OFFICIAL STAR CLASS MEASUREMENT CERTIFICATE

- YACHT NO. 3358
- L.O.A. 22' 8 1/2"
- MAST FROM B 31' 9"
- BOOM LENGTH 14' 7"
- JIB STAY FR. B 22' 6 1/2"
- DIMENSION "A" 94"
- "B" 46 5/8"
- "C" 50 7/8"
- "E" 83 5/8"
- "G" 49"
- "K" 30 3/4"
- "M" 1"
- "N" 7 7/8"
- "O" 11"
- "P" 12"
- "R" 77 1/2"
- "S" 24 1/2"
- "T" 160"

Report from International Measurement Committee

Star No. 3358 Owner Geo. B. Davis
Builder Harold B. Davis Measurer Geo. T. Davis
1236 W. Pierce St.
Milwaukee, Wis.

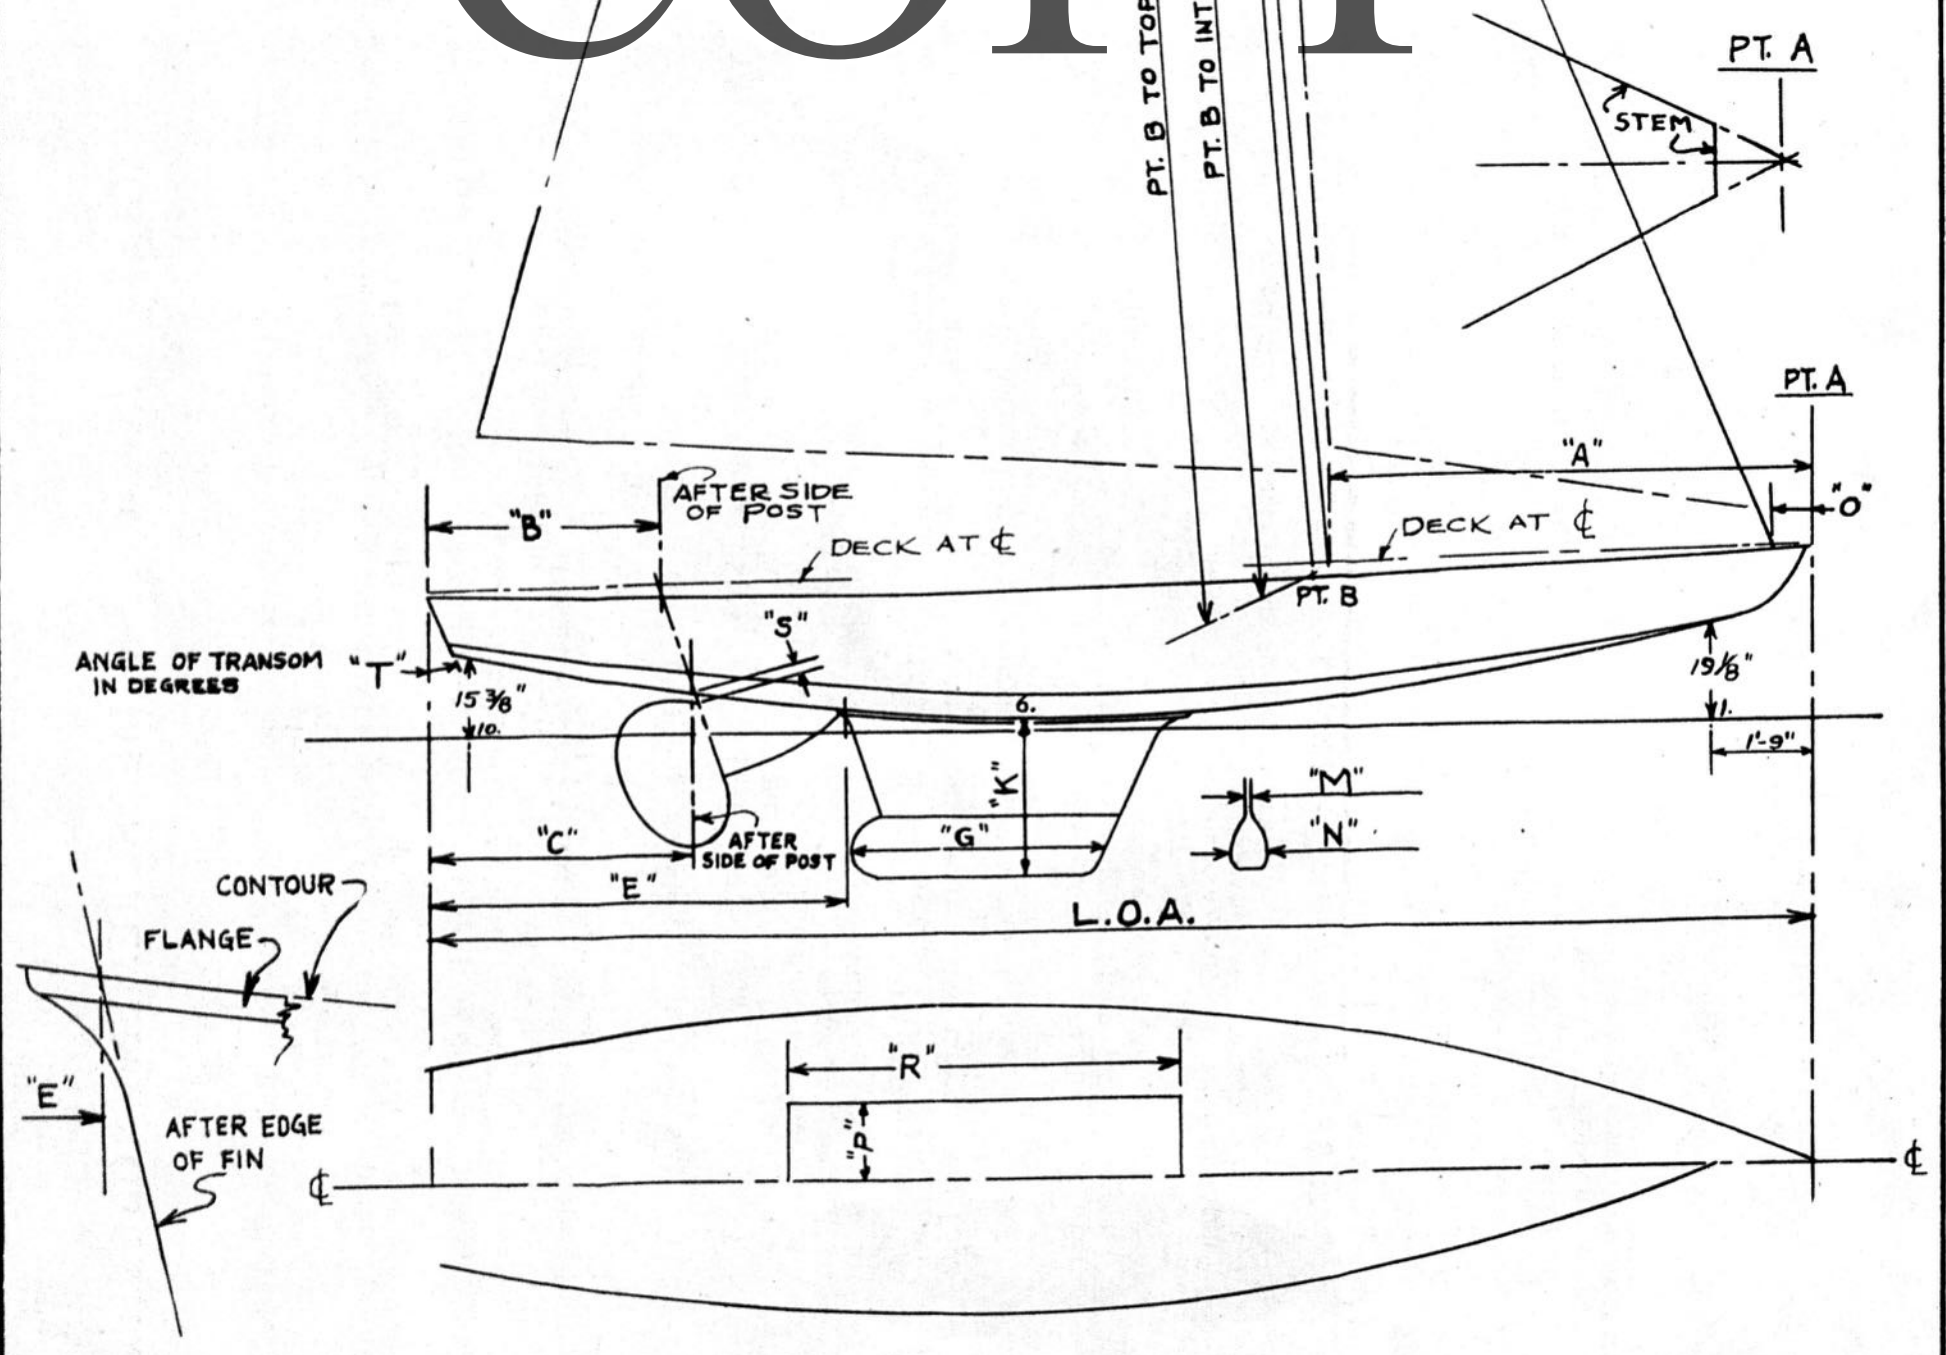
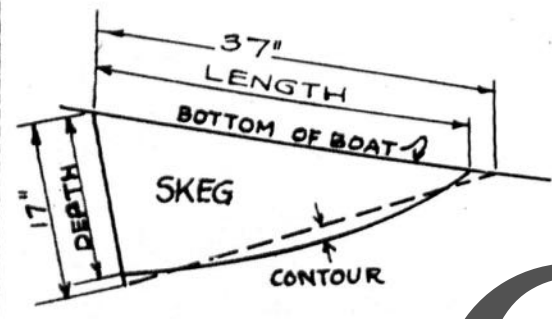
The Measurement Certificate for this boat cannot be approved due to the following points which do not comply with the Specifications:

1. - Keel HT - (D) $1\frac{1}{2}$ " over. (B. 1st)
2. - 5" $1\frac{1}{4}$ " over - (A/H - 2nd)

RECHECKED + ALTERED

KEEL HT (D) $5\frac{1}{2}$ "

DIMENSION "S" $1\frac{1}{2}$ "
